Access Compliance Report Public Rights-of-Way (Curb Ramps)

Intersection ID: 10034789Main Street: POTOMAC_RIVER_PYCross Street: N/ALocation: WADA ID: A1F52EA16398Ramp Type: PerpInitial Pass/Fail: FailOverall Compliance: NoSeverity Score: 12.5

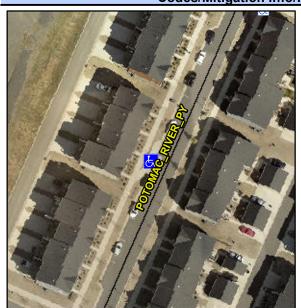
Possible Solutions:	
Remove & Replace Entire Ramp.	ı
	•
	1
	ı
	ı
	ı
Surveyor Notes:	ı
N/A	ı
PROW/ADA:	
Not Found, R304.2.2	'
	,

Field Measurements/Component Compliance							
Comp	liance Description	Data	Comp	liance Description	Data		
N/A	Ramp Length (in)	78.0	No	Ramp Slope (%)	8.6		
Yes	Ramp Width (in)	56.0	Yes	Ramp XSlope (%)	0.3		
N/A	Flare Type LT	N/A	N/A	Flare Type RT	N/A		
N/A	Flare Slope LT (%)	N/A	N/A	Flare Slope RT (%)	N/A		
N/A	Flare Traversable LT?	No	N/A	Flare Traversable RT?	No		
N/A	Landing Length (in)	N/A	N/A	DWS Provided?	N/A		
N/A	Landing Width (in)	N/A	N/A	DWS Contrast?	N/A		
N/A	Landing Slope (%)	N/A	N/A	DWS Length (in)	N/A		
N/A	Landing X Slope (%)	N/A	N/A	DWS Full Width?	N/A		
N/A	Landing Curb? (Y/N)	N/A	N/A	DWS Offset (in)	N/A		
N/A	Shared Landing?	N/A					
N/A	Gutter Ponding?	N/A	N/A	Gutter Slope (%)	N/A		
N/A	Gutter Lip Ht (in)	N/A	N/A	Gutter X Slope (%)	N/A		
N/A	Painted X Walk1?	No	N/A	Painted X Walk2?	N/A		
	X Walk 1 Direction	To E		X Walk 2 Direction	N/A		
N/A	X Walk 1 Width (in)	N/A	N/A	X Walk 2 Width (in)	N/A
